Submissions Report

PARKES SOLAR FARM

Project Title: Parkes Solar Farm Submissions Report

Figure 3 Travelling stock route

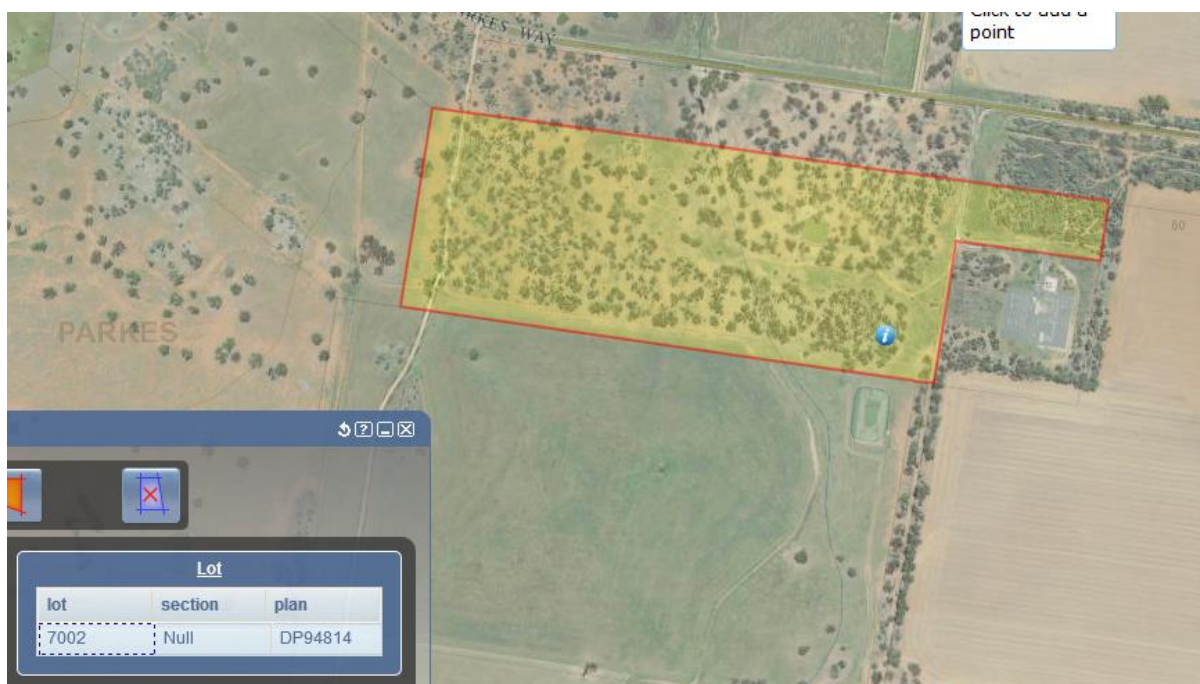
CWLLS raises that a fence running directly to a busy road creates considerable risk at its end point (where cattle go around it). Hence CWLLS advises that a dogleg fence should be constructed with a wing extending west to the edge of Ridgy Creek. (Total length approx. 700 m.) That would provide safety with the drover locating camp and observation point at Ridgy Creek end of the fence, with knowledge that traffic and cattle over by the substation cannot collide.

- **Neoen to propose suitable stock fencing (as per green line on Figure 4) and new gate at a suitable location that suits the construction access requirements (and operation if required).**
